SERVICE BULLETIN

APPLICABILITY: 2010-19MY Legacy and Outback
 2014-19MY Forester
 2012-19MY Impreza
 2013-19MY Crosstrek (Exc. 19MY PHEV)
 2015-19MY WRX
 2019-20MY Ascent

NUMBER: 16-103-16R

SUBJECT: Transmission Fluid Seepage

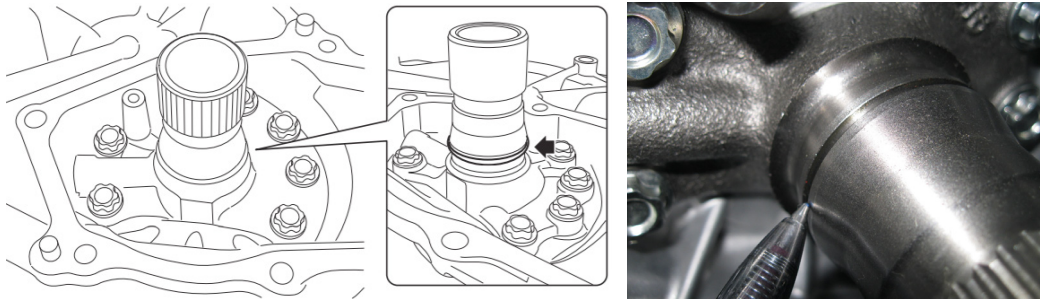
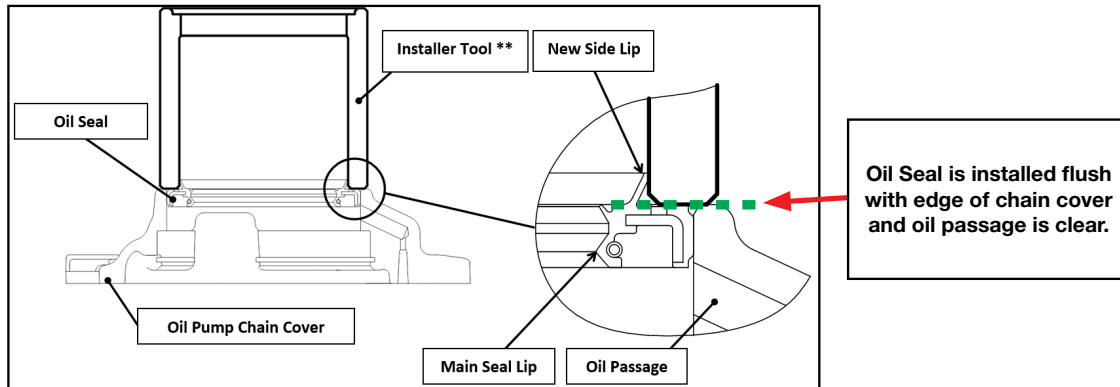
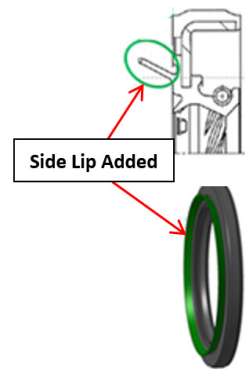
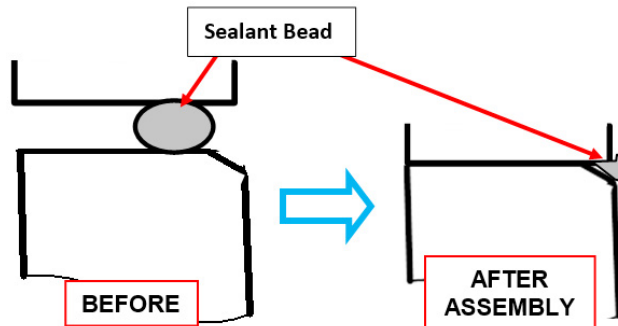
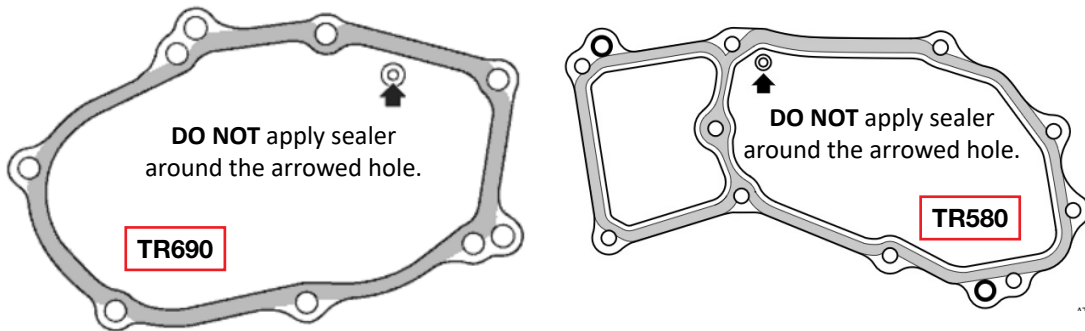
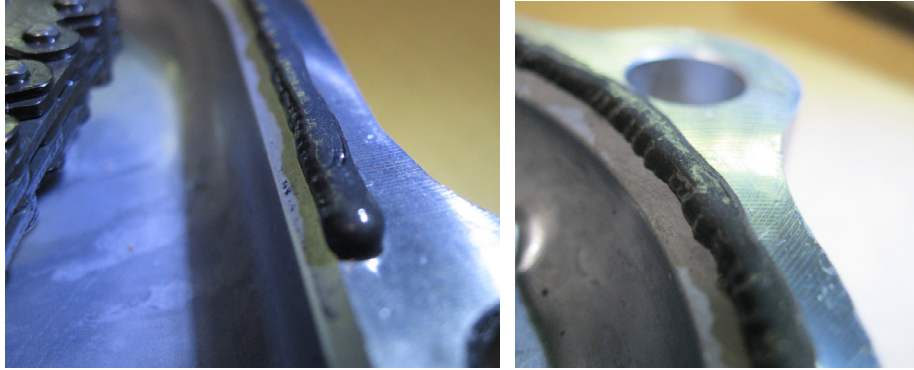
NOTE: Should the cover need to be replaced, always confirm the new part has the new-style input shaft seal with the additional side lip as described below before installation.

- The re-designed input shaft oil seal has a new side lip added to supplement the existing main seal lip. The purpose of the additional side lip is to direct the flow of dust and water around the seal and away from the sealing surfaces.
- Apply CVT fluid to the main seal lip **only** before installation.
- When installing this new seal, it is **STRONGLY** recommended to use the proper installer tool ****OPTIONAL Special Tool 927890000** as shown in the illustration below. Otherwise, If the seal were to be installed too deep into the bore of the chain cover (beyond flush with the chain cover edge as shown below), the oil passage may become restricted or blocked.

- **IMPORTANT:** Before reassembly, always replace the **ONE TIME USE** plastic sealing ring on the center support and thoroughly lubricate it with CVT fluid.
